ADDENDUM # 2
NOTICE TO BIDDERS
BID#23-121 Fargo Road Water Tank Recoating and Improvements

May 23, 2023

3. Antenna Photos on Top of Tank (Attached)

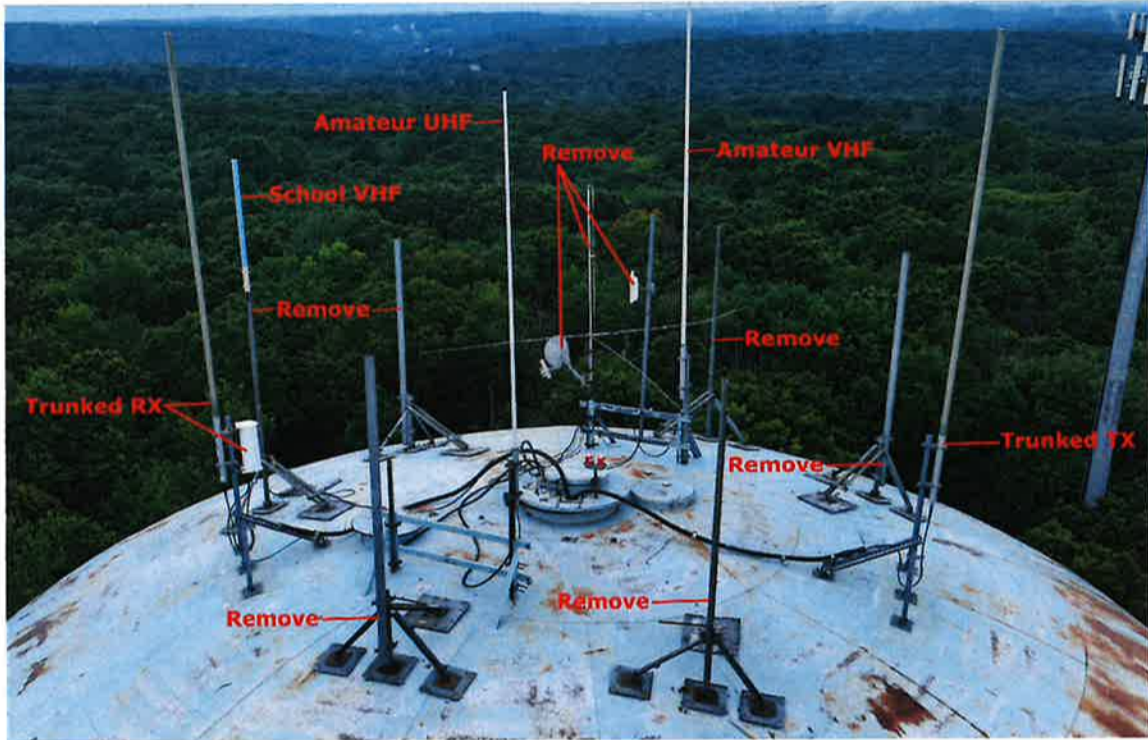
Cable Exit – Unsure on the ladder orientation with regards to the cable exit and the hatch opening. We will work with the engineer on the cable exit port.
